City of Santa Barbara
Planning Division

Memorandum

SUBJECT: **Staff Evaluation of additions and alterations to a City Landmark, the San Marcos Building as it applies to the Historic Resource Design Guidelines.**

ADDRESS: 1124-31 State Street and 9 West Anapamu Street, San Marcos Building

*#2 Above: San Marcos Courtyard original configuration
with full arcade.
Robert Easton Collection, Santa Barbara Public Library*

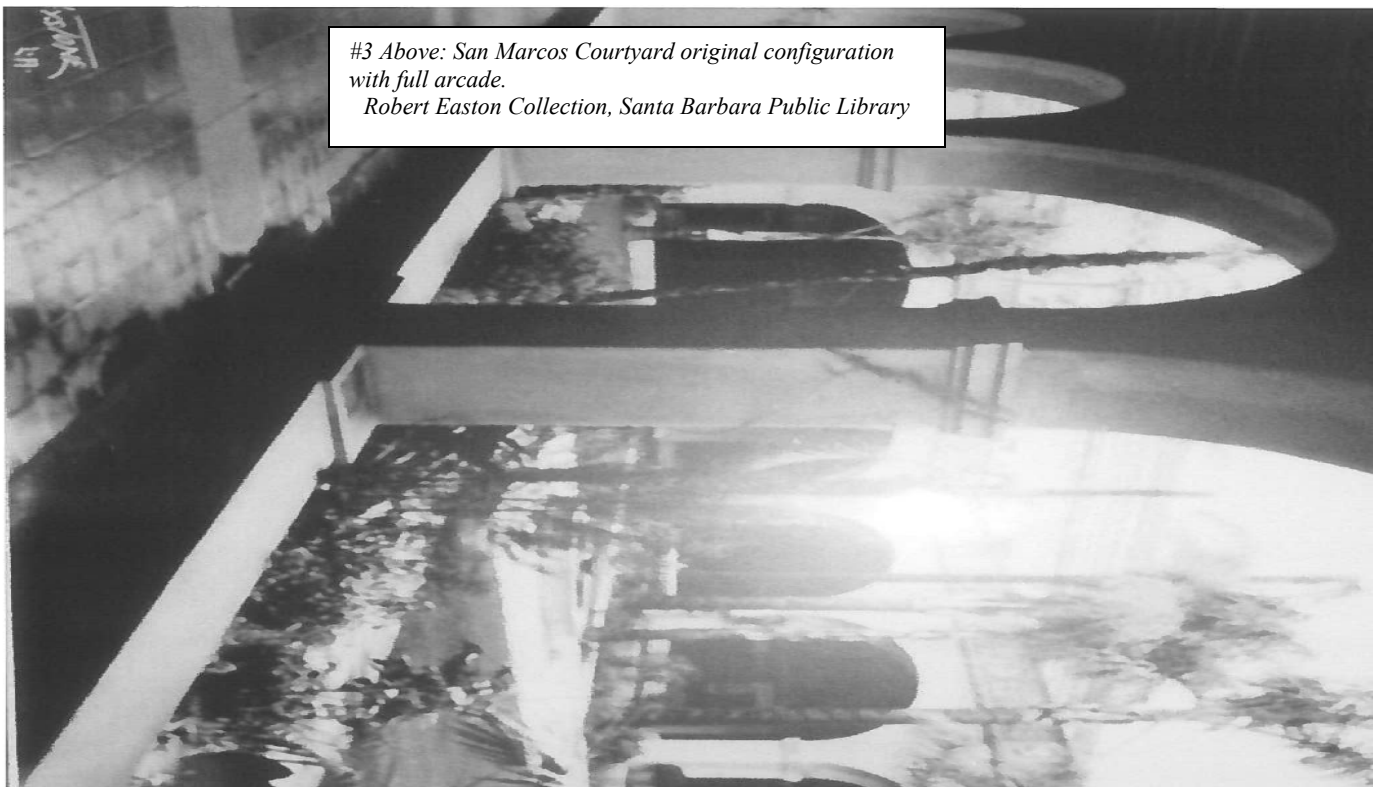
Discussion: Although this storefront was originally recessed as part of the arcade, this proposal only proposes to add wood doors in the stark existing storefront that currently does not interact with the courtyard. The addition of doors to the commercial space will enhance the activity of the courtyard. It should be noted that when more extensive alterations are proposed, the project should consider recessing the storefronts to return the original arcade to the courtyard. The wood doors will not destroy historic materials, features, or spatial relationships that characterize the property. The new wood doors being in the new storefront will be compatible with the historic materials, features, size, scale and proportion and massing to protect the integrity of the property and its environment.

*#4 Above: San Marcos Building after 1926 reconstruction,
State Street Elevation.
Robert Easton Collection, Santa Barbara Public Library*

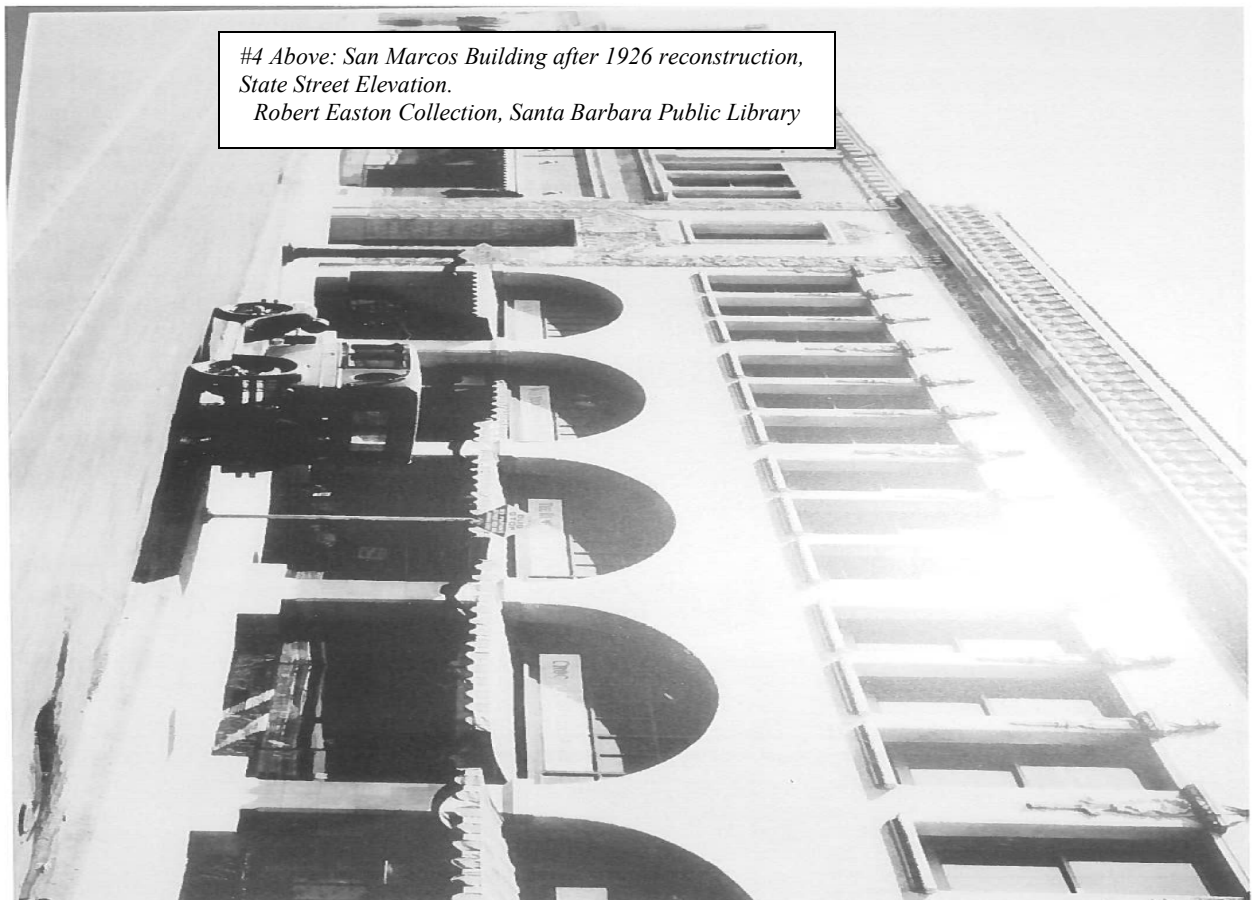
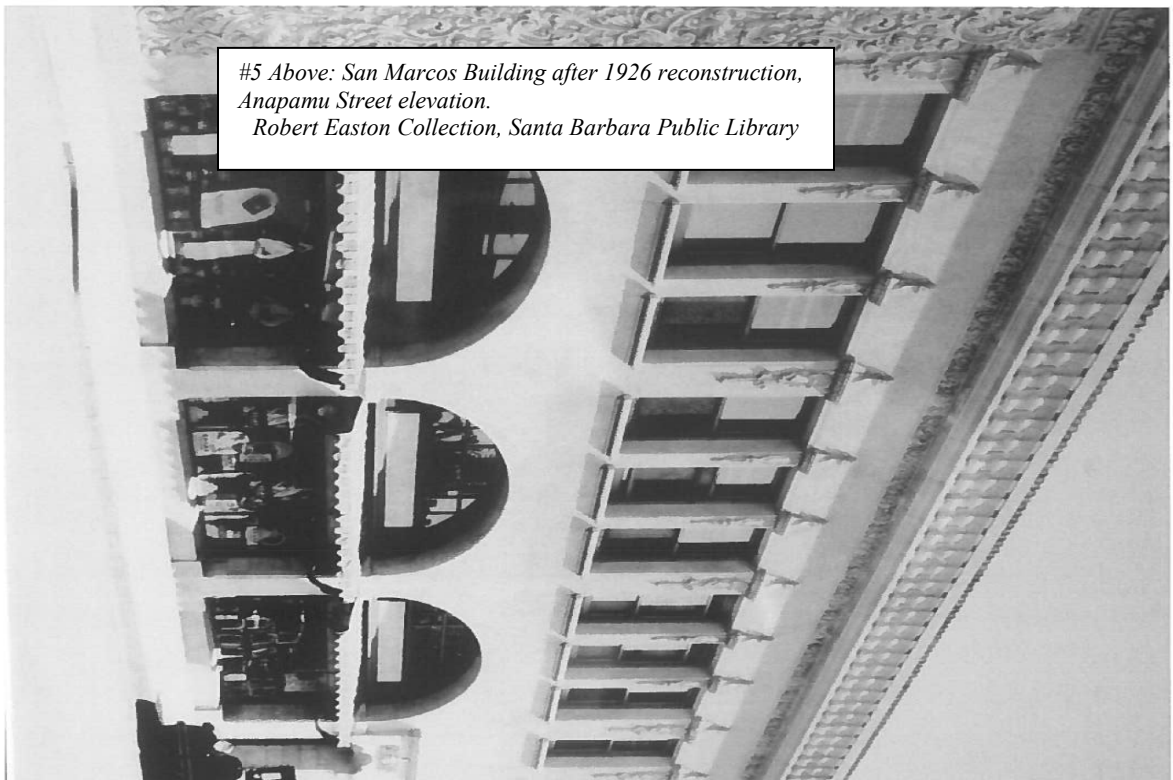
Discussion: The four other round bay transom windows on State Street were all filled with stucco. Originally, the round bay transoms all had divided lights and the storefront at the face of the building recessed just behind the columns dividing the bays. Based on the photographic evidence provided in this report, the proposal to bring the existing storefront forward will return the bay to its original configuration. However in order for the Commission to make the required finding, the storefront should be recessed just behind the column and the transom design should match the original with more divided lights.

The Urban Historian recommends the State Street storefront match the original configuration behind the columns that divide the bay and with divided lights in the transom to match the original as provided by photographic evidence. The State Street elevation is the most visible elevation of the City Landmark and the Commission is required to make the following finding per SBMC# 22.22.070, "The exterior alterations are being made primarily for the purposes of restoring the Landmark to its original appearance or in order to substantially aid in the preservation or enhancement of the Landmark." The other alterations 2-4 proposed will enhance the use of the San Marcos building and meet the Secretary of Interior Standard Number 9.
